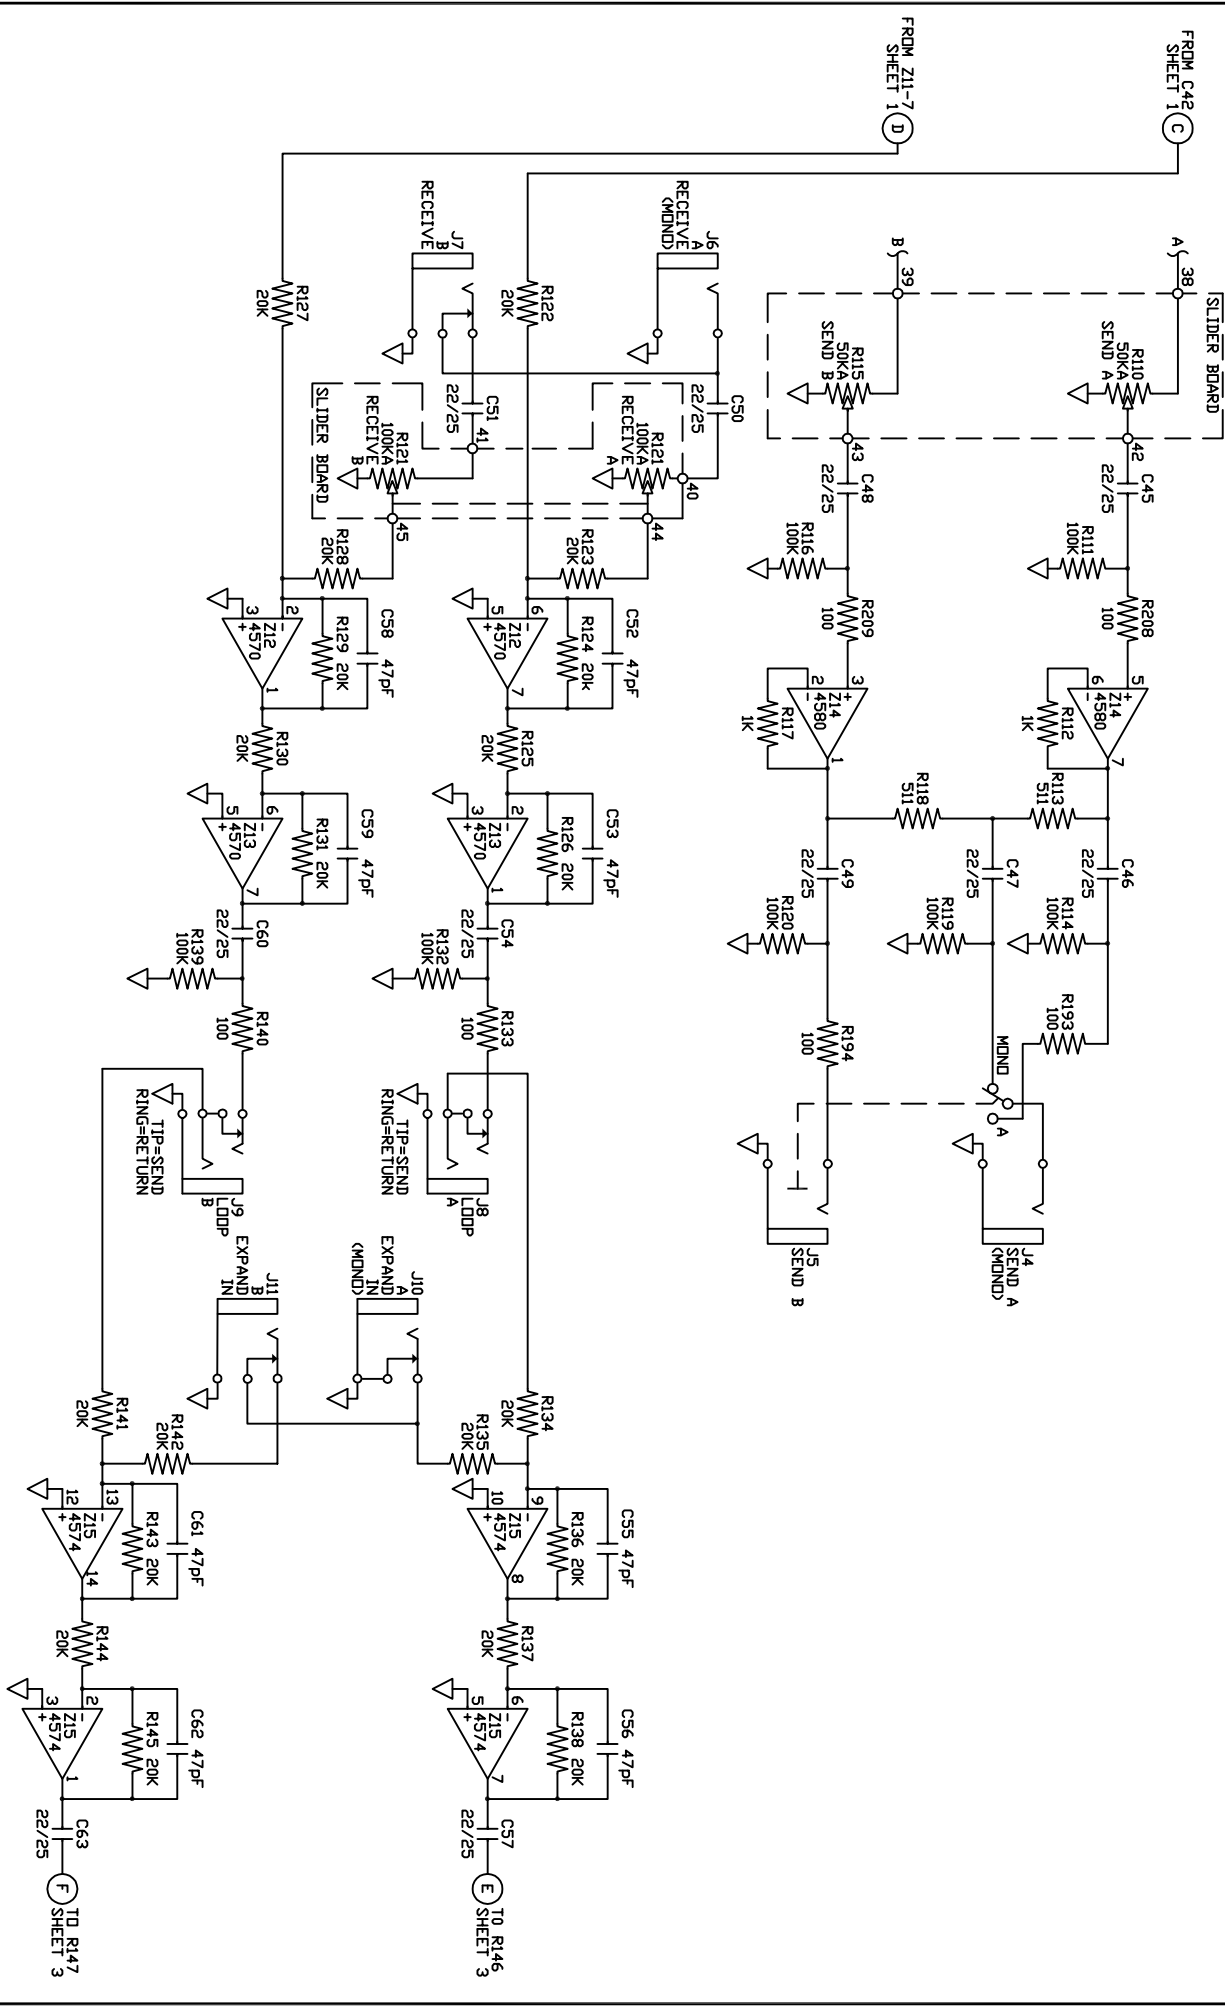
REPLACE (R10) 15M WITH 4" JUMPER (04303)
 REPLACE (R9) 15M WITH 1.74M (03747)

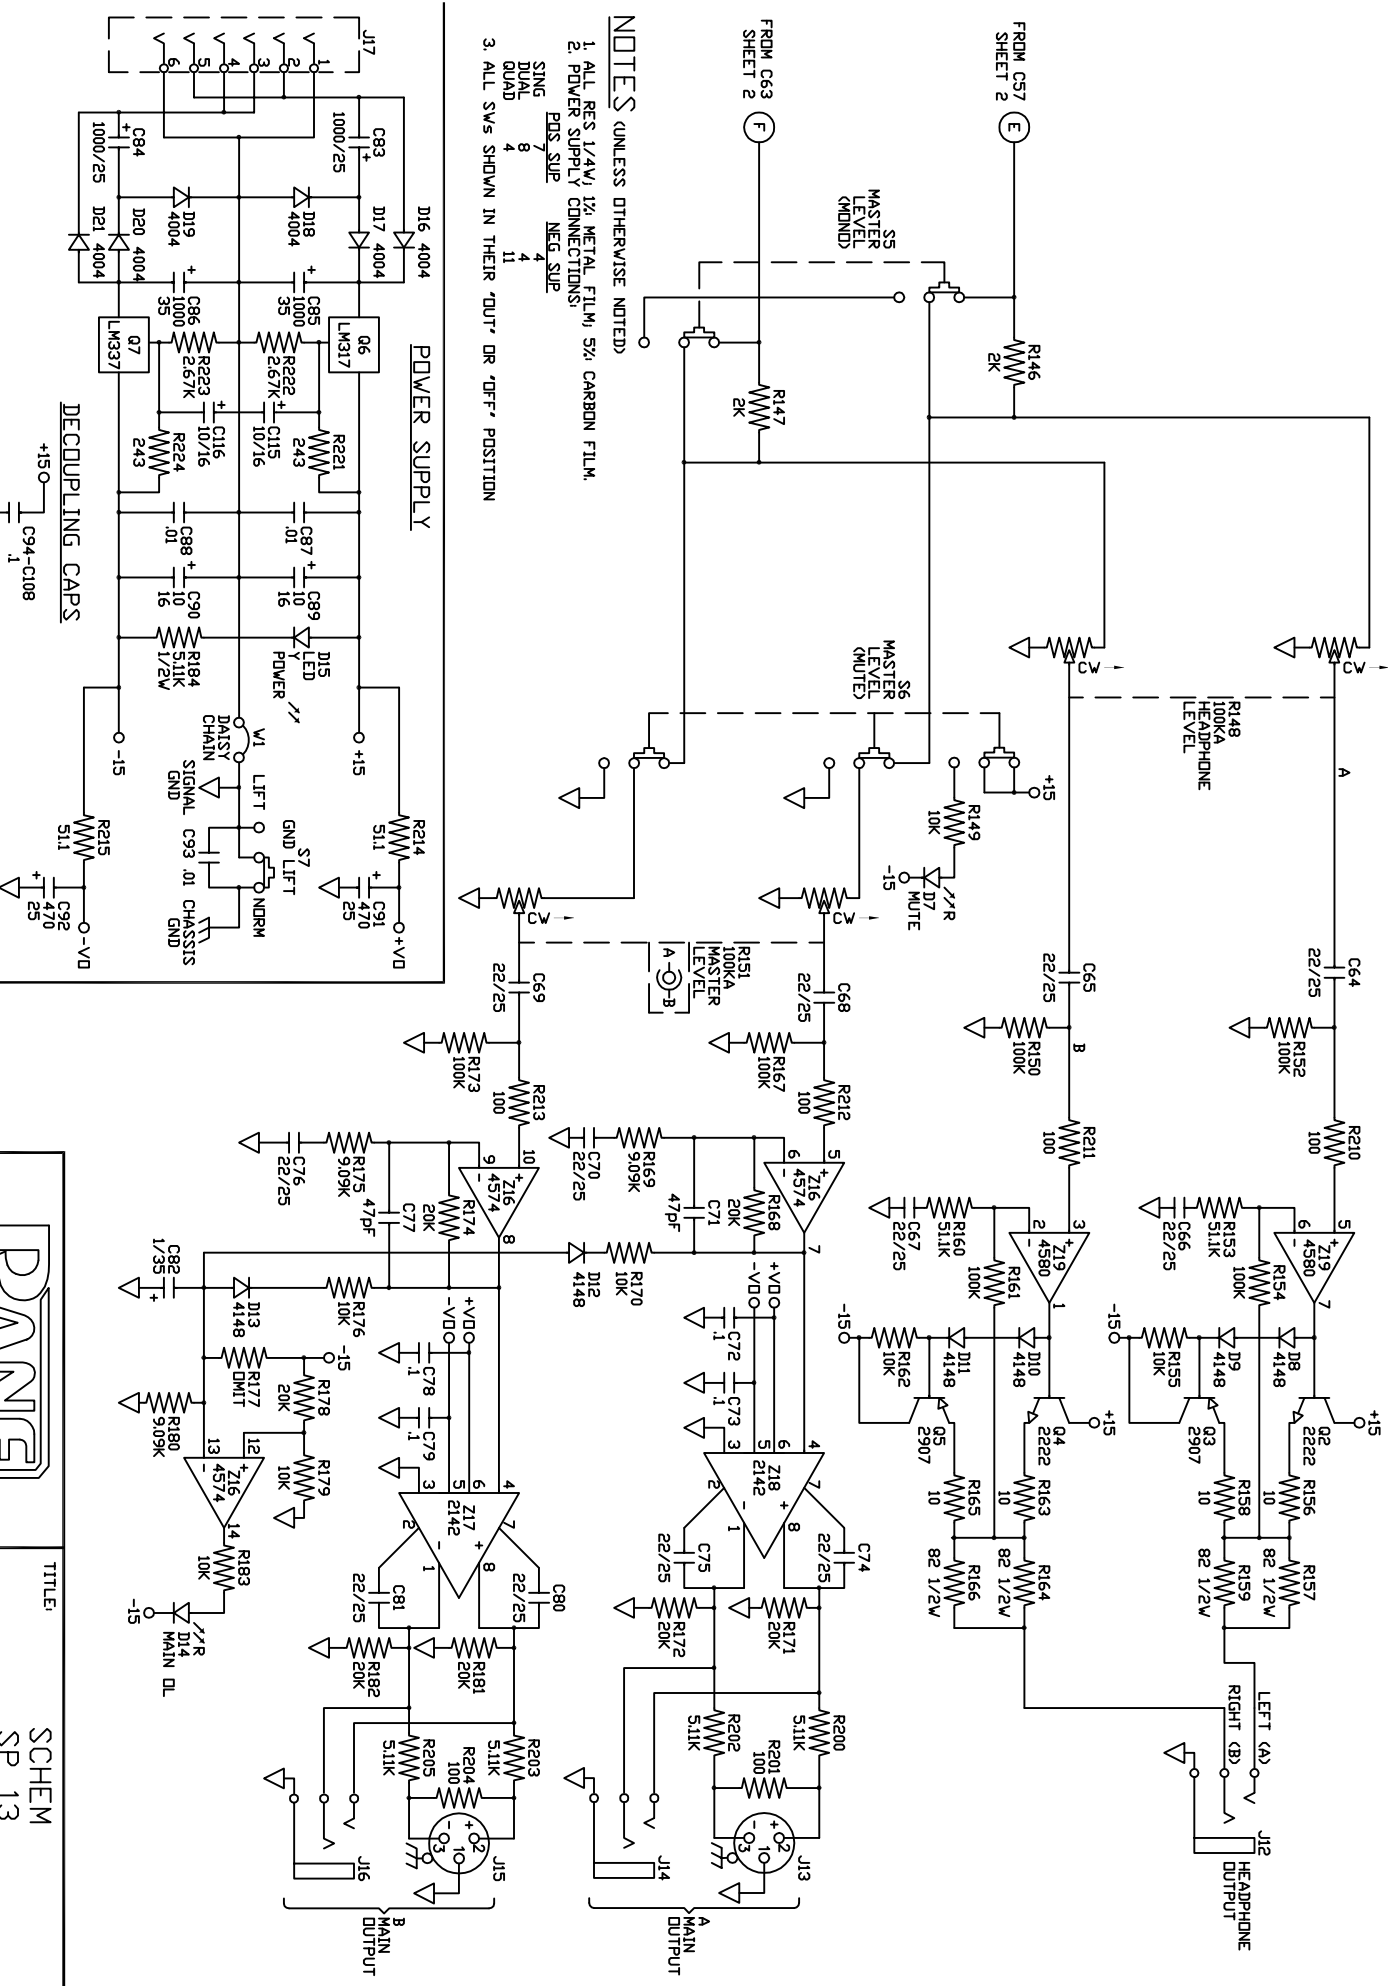
DO NOT PLACE D24 & D25 THROUGH FRONT PANEL

REPLACE (Z2) 4570 WITH DPA2604 (03614)
 REPLACE (R31) 20K WITH 1.74M (03747)
 REPLACE (C8) 22/25 WITH 00047 (00173)

J25-1 (#33) TO J26C AS SHOWN
 SOLDER WIRE FROM J25-1 (#33) TO J26C AS SHOWN
 CUT HEADER PIN J26-1 (#38)

REMOVE S2
 REPLACE R191 WITH 1K (00003)
 REMOVE V23 AND ADD R500 AS SHOWN
 SOLDER WIRE FROM V23/R191 TO R50/Z8-13R14 AS SHOWN
